# United States Department of the Interior

## **DECISION RECORD #1 FOR WILDGAL-DIXIE FOREST HEALTH TREATMENTS ENVIRONMENTAL ASSESSMENT DOI-BLM-ORL040-2009-017**

**WILDGAL-DIXIE FOREST HEALTH TREATMENTS EA COMMENTS AND RESPONSES**

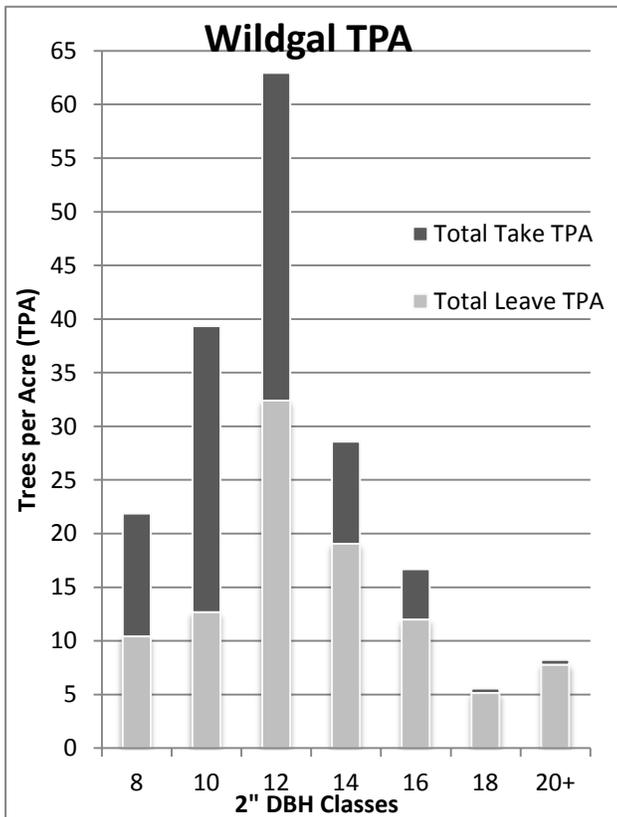
*Comment: Please utilize and implement the knowledge we have gained through field trips by retaining large-diameter Douglas-fir, ponderosa pine and incense cedar trees for their disproportionate ecological, fire-resiliency, recreation and social values.*

Response: According to cruise data, approximately 98.9% of the trees scheduled for harvest are twenty (20) inches in diameter or smaller, thereby resulting in retention of most of the large diameter trees of all species in the harvest area. The Wildgal TPA figure shows approximate retention/harvest levels of trees based upon post-marking plot data and actual pre-harvest cruise data for the sale area. More detailed data about stand and species tables are available at the KFRA office.
